# PERMIT

## SEWAGE DISPOSAL SYSTEM

SUBDIVISION W. Friendship Estates - I LOT 36 ROAD 3101 Fox Valley Drive

PROPERTY OWNER Altieri Homes / AHMED

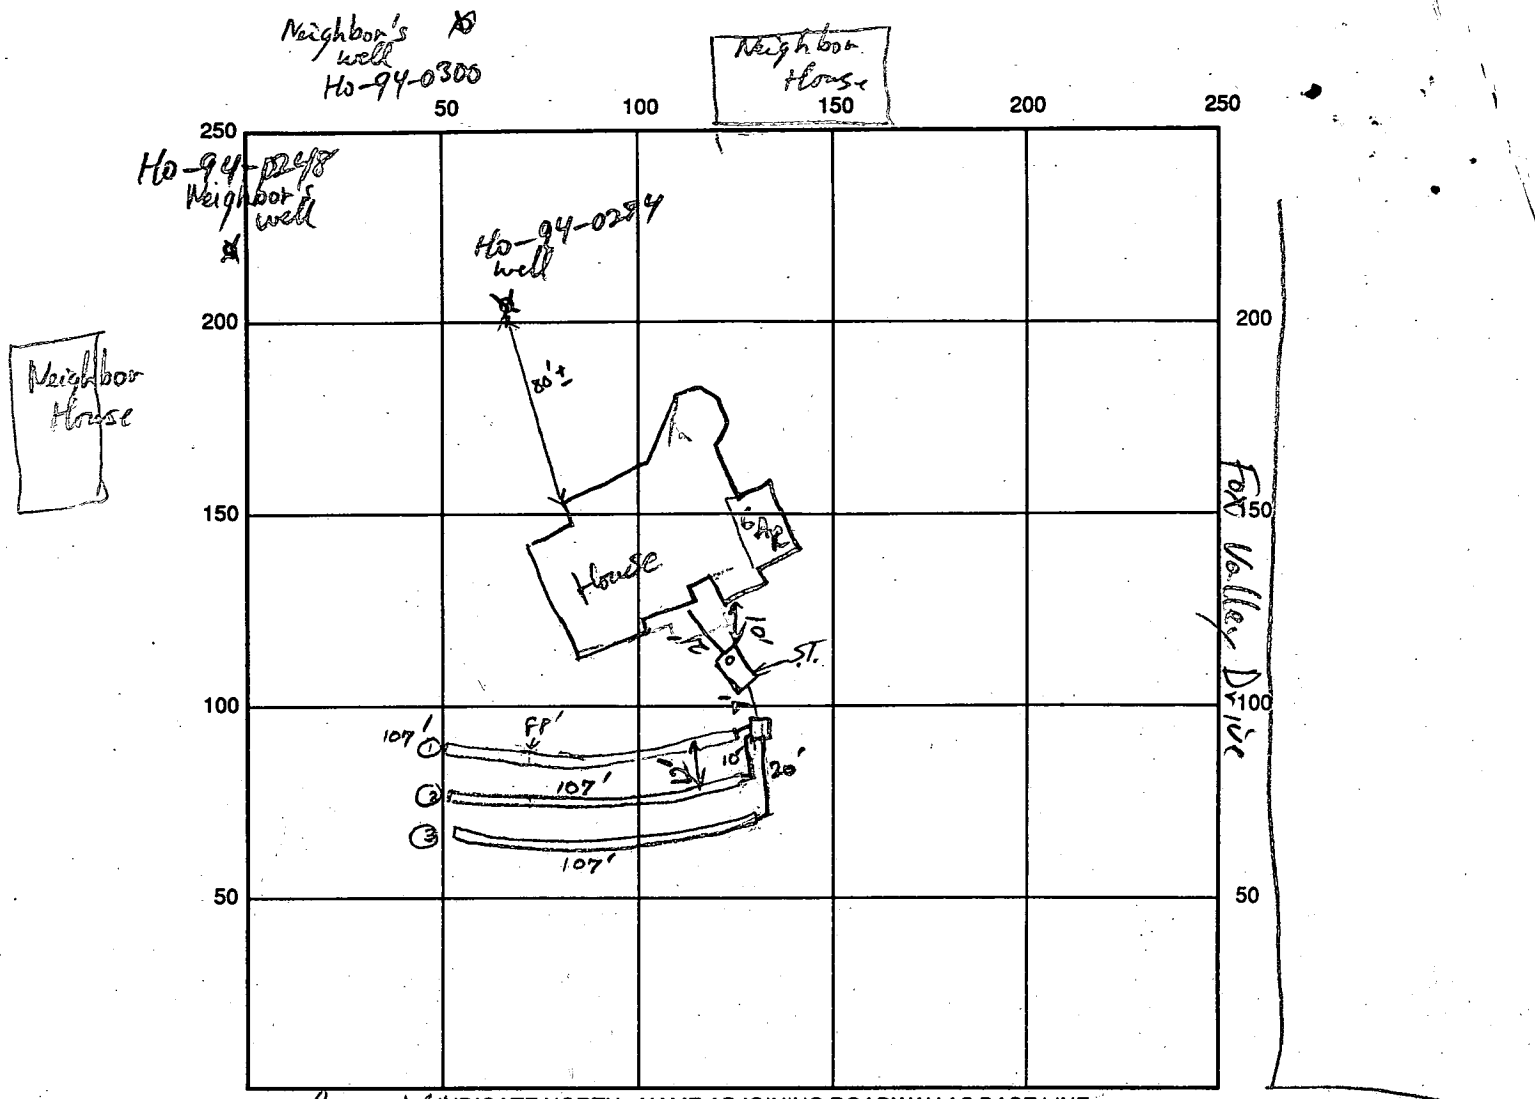
ABSORBENT AREA 963 SQ. FT. *change to 3-107' long trenches is OK / R/P finally*

REMARKS: *they* Installed two 88 ft trenches, will increase to three 107' long trenches to save repair area. Open trenches OK to gravel fill + cover last 88 ft of 2 trenches when completed. If problem with excessive rocks call for another open trench inspection. R/P 3/20/95

3/21/95 Final - OK to cover all work. DKS
